Report on Consultation (Route Options)
Loch Kemp Storage Scheme 275 kV Grid
Connection
May 2025

REF: LT366

Title: Report on Consultation (Routing)
Figure 1: Route Options

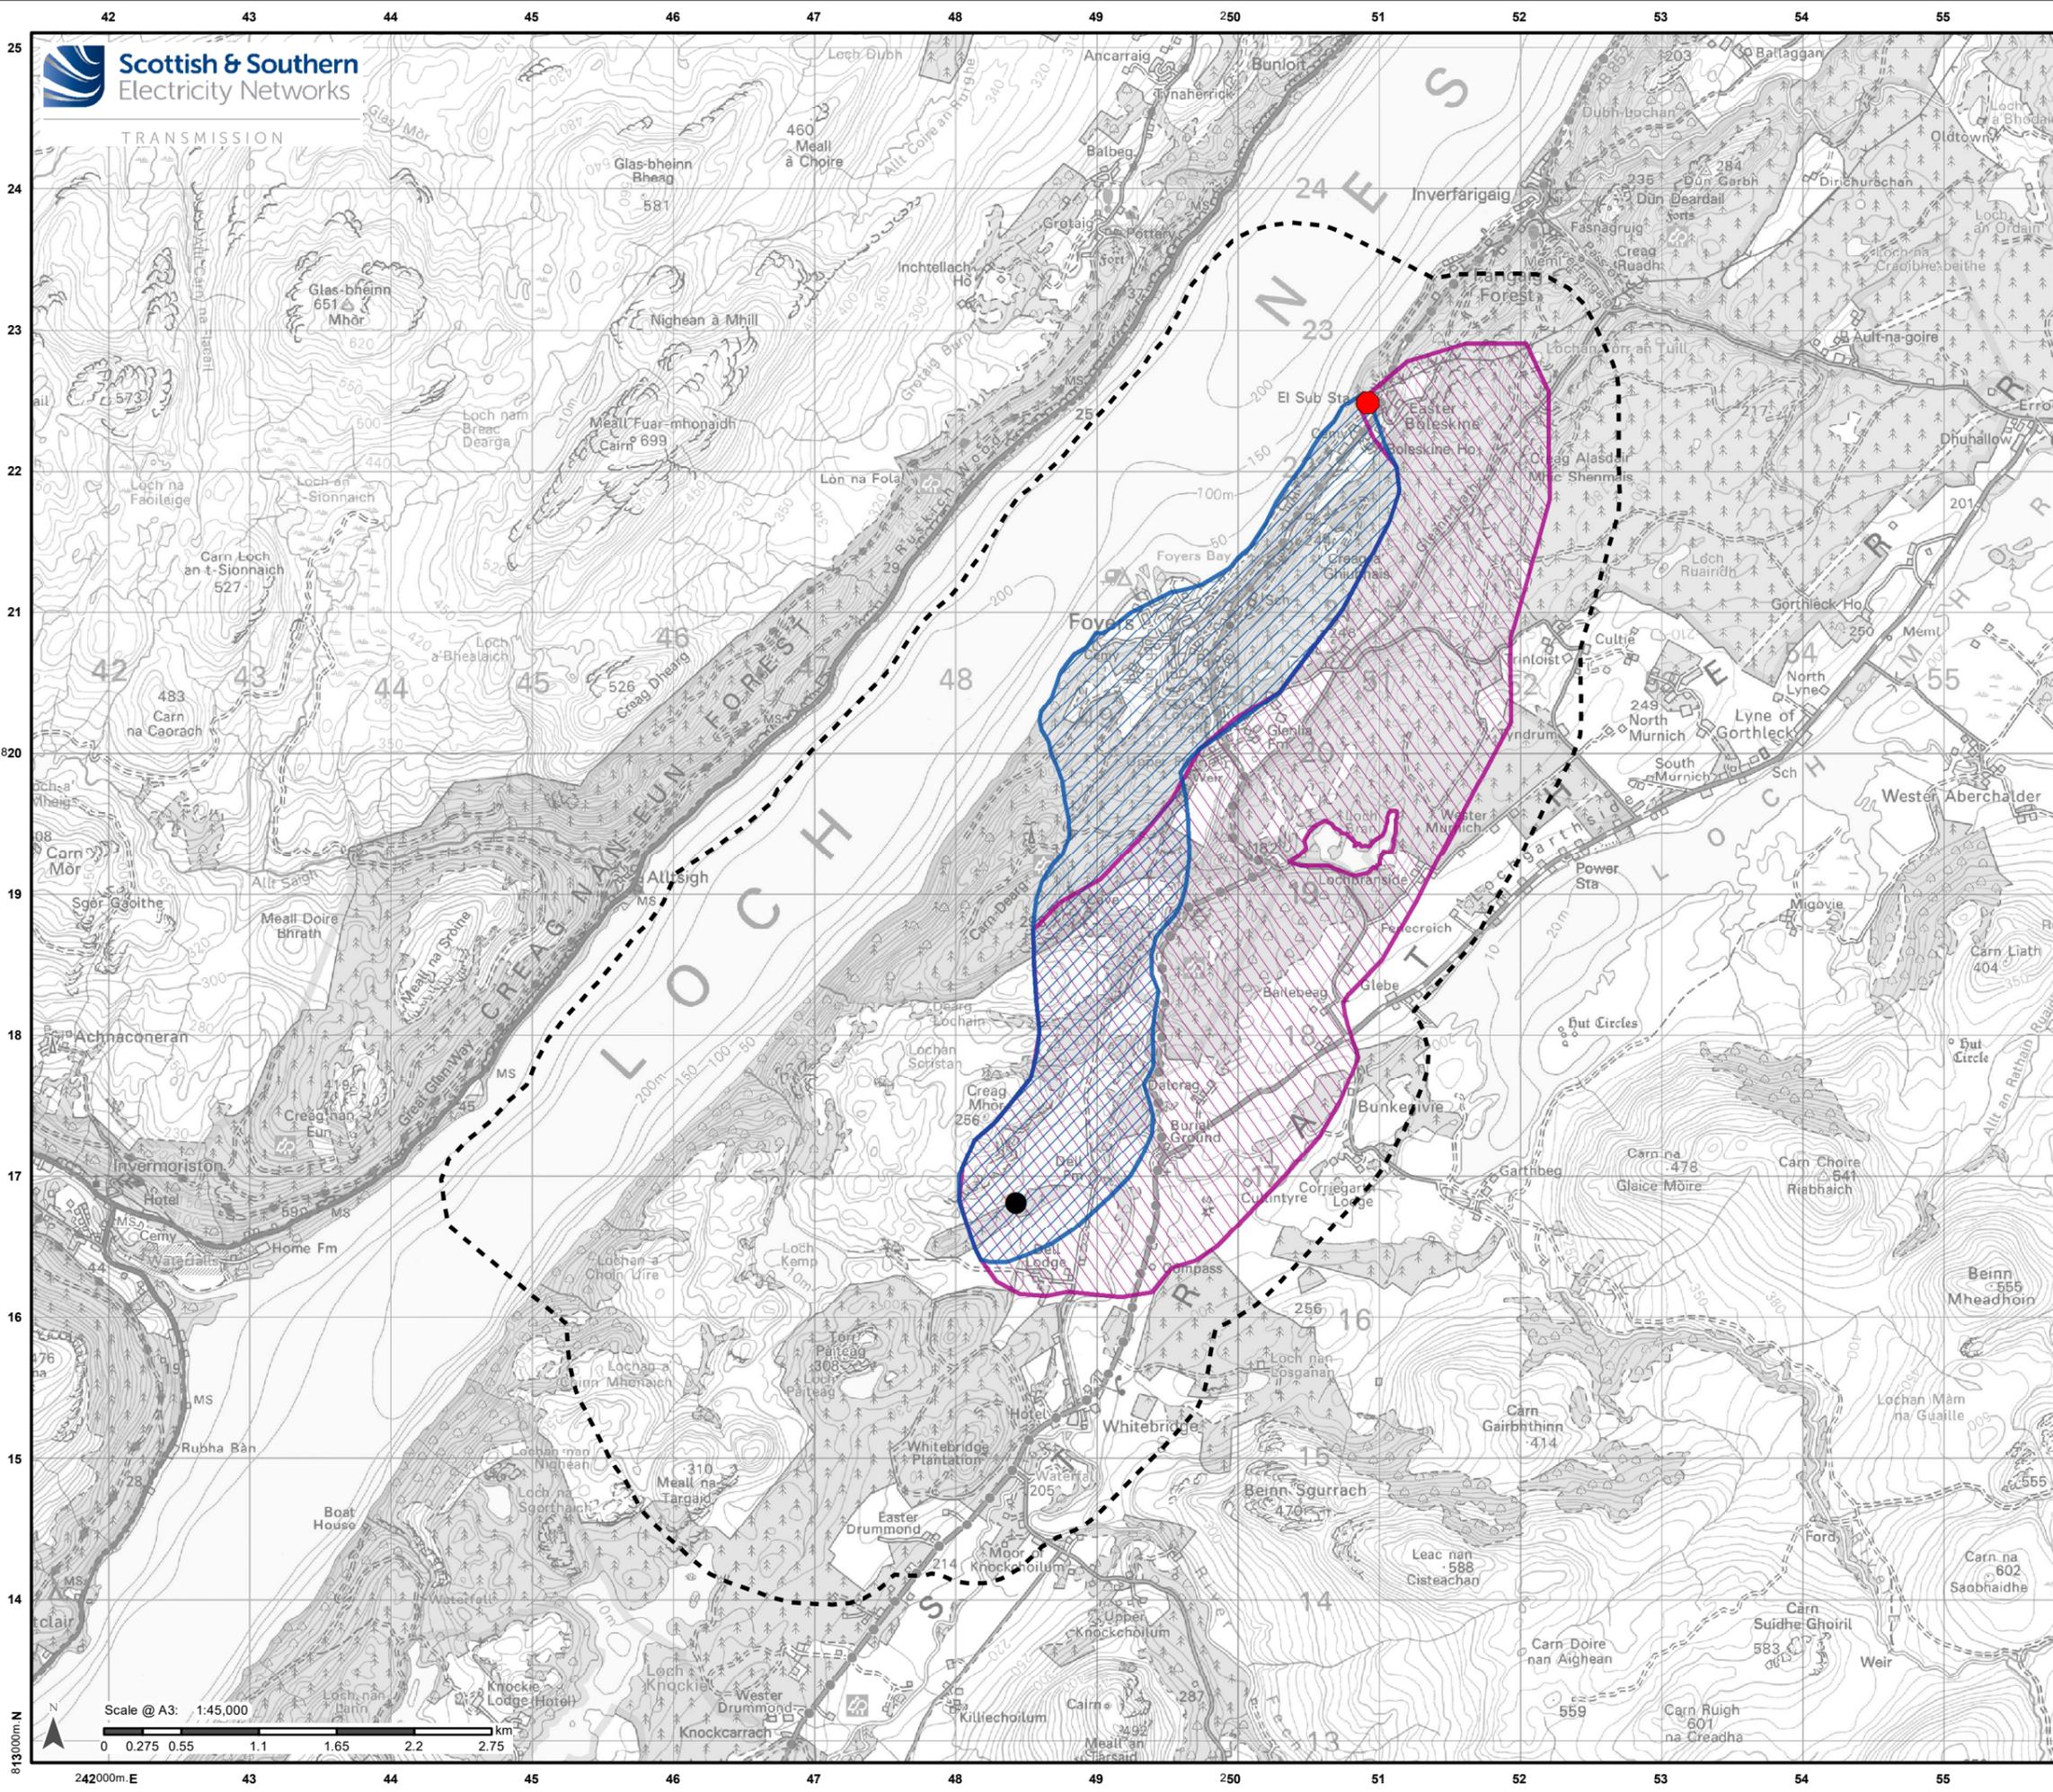
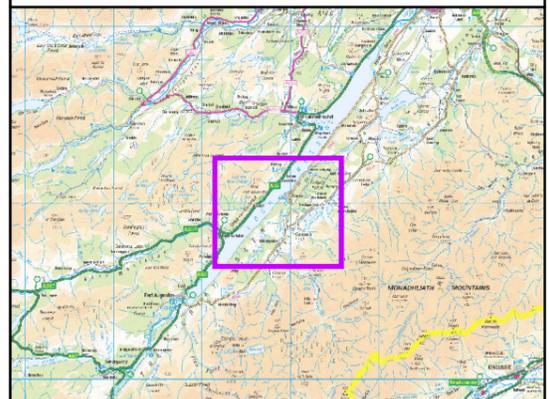
Stakeholder	Summary of Feedback	Response by SSEN Transmission
Statutory		
The Highland Council (THC)	No response has been received from THC.	SSEN Transmission will continue to keep THC informed of the Proposed Development.
NatureScot (NS)	NS identify that Route Option 1, now the preferred route option, could potentially affect Loch Bran SSSI. NS recommend an early indication of route past this SSSI, as they believe it is possible to avoid impacts on the SSSI with good route choice.	The focus of NS's response is noted. Whilst Route Option 1 has been designed to exclude Loch Bran SSSI, any potential effects on this designated site will continue to be considered during Stage 3: Alignment Selection.
	NS noted that both routes would initially cover the same landholding within the Dell Estate. Parts of this landholding have been identified for proposed peatland restoration, as part of the Loch Kemp Pumped Storage Scheme application. These peatland areas have been selected to be restored to offset peatland losses, should the Scheme be built. Therefore, NS note that it is important that the cable connection avoids these areas, otherwise, NS advise that additional offsetting areas are secured. NatureScot advise that the applicant identify these areas of peatland to enable the cable route to avoid them.	The peatland restoration areas noted within NS's response, have been identified within Volume 4, Appendix 10.7: Outline Habitat Management Plan (non-SAC) of the EIA Report for the Loch Kemp Storage Scheme (ref: ECU00003398). With careful consideration at Stage 3: Alignment Selection, it is anticipated that these areas can be avoided. This will further be considered during the alignment selection stage of the project.

Scottish Environmental Protection Agency (SEPA)	SEPA provide no comment on the selection of a preferred route at this stage, although will have an interest once the alignment and construction corridor of the UGC is known, along with any baseline habitat and peat depth data. SEPA encourage the Applicant to make the most use of disturbed areas, where possible.	SSEN Transmission will continue to liaise with SEPA once an alignment for the UGC is identified. This will be informed by more detailed habitat and peat depth surveys through the alignment stage.
Historic Environment Scotland (HES)	HES welcome that the Consultation Document explains the need for the Proposed Development and the approach to route stage. HES identify that based on the current information available, the preferred route (Route Option 1) is unlikely to have significant adverse impacts on the A-listed building of <i>Foyers Hydroelectric Power Scheme, Former Aluminium Smelter, Powerhouse and Smelter</i>	SSEN Transmission are pleased to note HES's response and welcome HES's comments in relation to this A listed building. Further consideration will be given to this aspect during Stage 3: Alignment selection.

Stakeholder	Summary of Feedback	Response by SSEN Transmission
	<p>(LB1880), as this would fall within Route Option 2.</p>	
	<p>HES identify a scheduled monument falling partly within Route Option 1 and partly within Route Option 2: <i>Dell Farm, burial mounds 350m NE of (SM4536)</i>.</p> <p>The monument is nationally significant as one example of a rare type of Pictish monument. It is an exceptionally fine field monument and has the potential to increase understanding of burial customs and society in the first millennium AD.</p> <p>HES welcome confirmation in Section 6.2.16 and Appendix 1 that direct physical impacts on this scheduled monument would be avoided through design during Alignment Selection. The establishment of a construction corridor of 40 m (30 m during operational phase) would entail the felling of trees along the construction corridor and the placement of cable joint bays and link pillars along the route.</p>	<p>HES comments are welcomed and have been noted. This scheduled monument, and other relevant designated cultural heritage assets, will be considered further during Stage 3: Alignment Selection of the Proposed Development, when HES will be re-consulted.</p> <p>It should be noted that it is anticipated that the construction corridor for the UGC would be 30 m wide and the Operational Corridor (OC) would be reduced to 20 m wide, although the corridor width could vary along the cable route during both construction and operation. For example, in areas of woodland, the width of the OC could vary depending on the type of woodland (based on species present) in proximity to the UGC.</p>

The Coal Authority	The Coal Authority has no specific comment.	SSEN Transmission note the Coal Authority's response.
Non-Statutory		
Forestry Land Scotland (FLS)	FLS welcome that the need and approach for the Proposed Development is clearly explained within the Consultation Document.	SSEN Transmission are pleased to note FLS's response and welcome FLS's comments in relation to route preference (noted below).
	<p>FLS note some factors that may have been overlooked during the appraisal of route options: The potential for visual impacts on tourist use of canal/Loch Ness for Route Option 2.</p> <p>Also, Route Option 1 has less forestry interaction compared with Route Option 2. The felling could dovetail with the FLS LMP for restocking of Ancient Woodland Inventory (AWI) areas with species in-keeping with the AWI designations.</p> <p>On balance, FLS agree that Route Option 1 is the most appropriate for further consideration at Stage 3: Alignment Selection, as it appears to afford the best opportunities to minimise impacts and provide mitigation opportunities.</p>	Comments by FLS on the route options presented are welcomed and will be considered further during Stage 3: Alignment Selection.

Stakeholder	Summary of Feedback	Response by SSEN Transmission
	<p>FLS encourage further discussion with SSEN Transmission on the Operational Corridor (OC) requirements for the UGC, particularly in exploring opportunities the Development could create, such as wildlife management access.</p>	<p>These comments are noted and SSEN Transmission will maintain engagement with FLS as the Proposed Development progresses.</p>
<p>Highland Raptor Study Group (HRSG)</p>	<p>Highland Raptor Study Group (HRSG) note that there is no reference in the report to breeding osprey within the Study Area, in addition to the presence of breeding white tailed eagle just outside the boundary of the Study Area.</p> <p>HRSG are happy to share the location of the nests of these species, in confidence.</p>	<p>HRSG's comments are welcomed. SSEN Transmission and their environmental advisors will be contacting HRSG as part of the baseline data collection for Stage 3: Alignment Selection of the Proposed Development.</p>

Title: Report on Consultation (Routeing)
Figure 2: Proposed Route Option

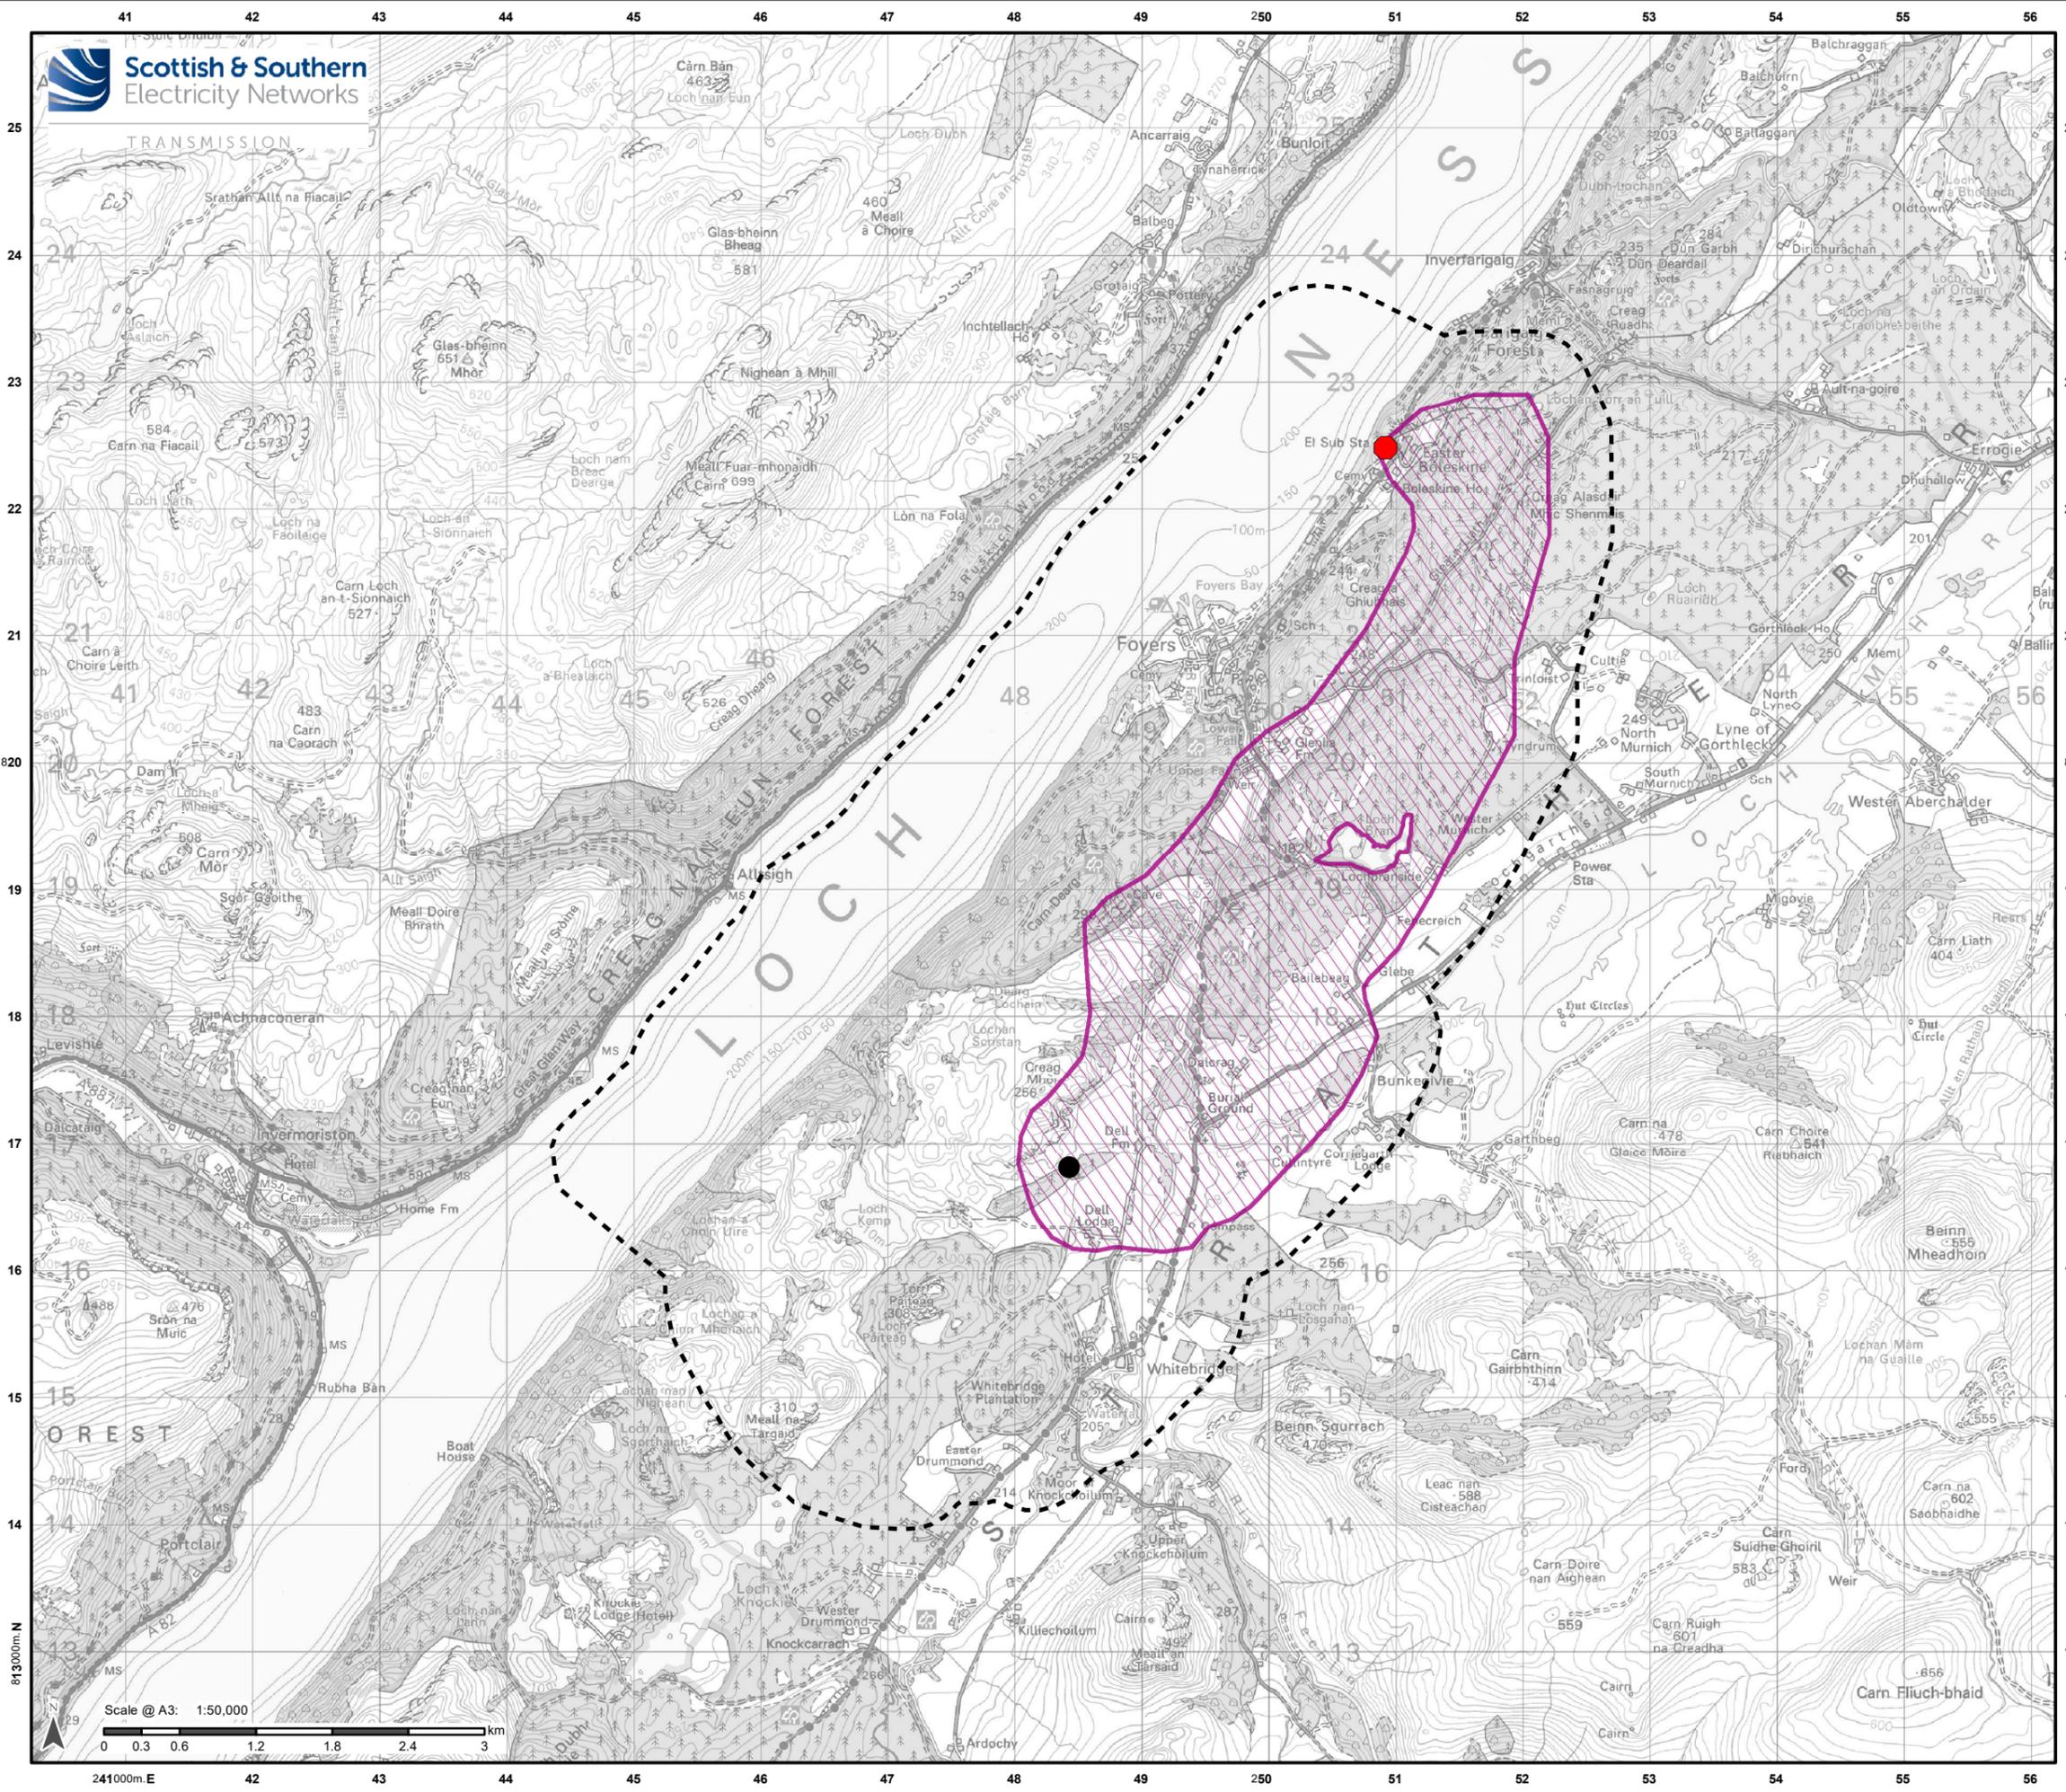
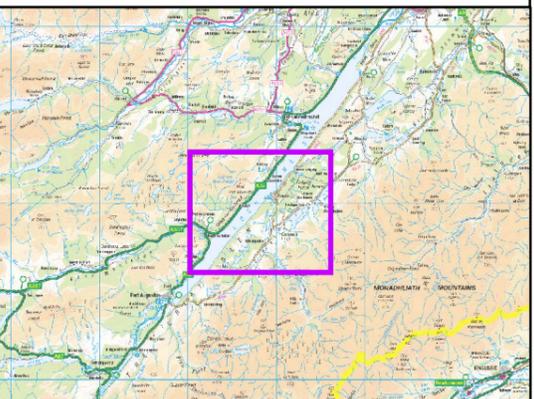
- 7.1.2 For Route Option 1, the Consultation Document¹ identified the most notable constraints were the natural heritage designations. From an engineering perspective, major crossings, in addition to the terrain and elevation, were noted as important considerations. Stakeholder comments noted that Route Option 1 would have less interaction with forestry compared with Route Option 2 but also highlighted the potential interaction with the Loch Bran SSSI, although acknowledged this could likely be avoided.

- 7.1.3 For Route Option 2, the Consultation Document¹ noted that felling of native woodland as identified within the AWI, would be required to facilitate the route option. The route option is dominated by non-native conifer plantation, as well as smaller areas of native woodland, that would likely be unavoidable. The Consultation Document also noted that it would be more difficult for Route Option 2 to avoid Annex 1 habitats, such as upland wet heath and dry heath, neutral grassland, natural lakes and ponds and upland acid grassland, which are also classified as habitats of high distinctiveness, with high value in terms of BU within the BNG SSEN Transmission Metric. From an engineering perspective, Route Option 2 poses similar constraints to Route Option 1, as it is also situated on unfavourable terrain and elevation. There was general agreement from stakeholders in relation to these constraints, also highlighting the potential visual impact on tourist use of the Loch Ness/canal and potential interaction with cultural heritage.

- 7.1.4 Having considered this feedback, SSEN Transmission has concluded that the preferred route option identified in the Consultation Document (Route Option 1) should be taken forward as the proposed route to Stage 3: Alignment Selection. The proposed route can be seen in **Figure 2**.
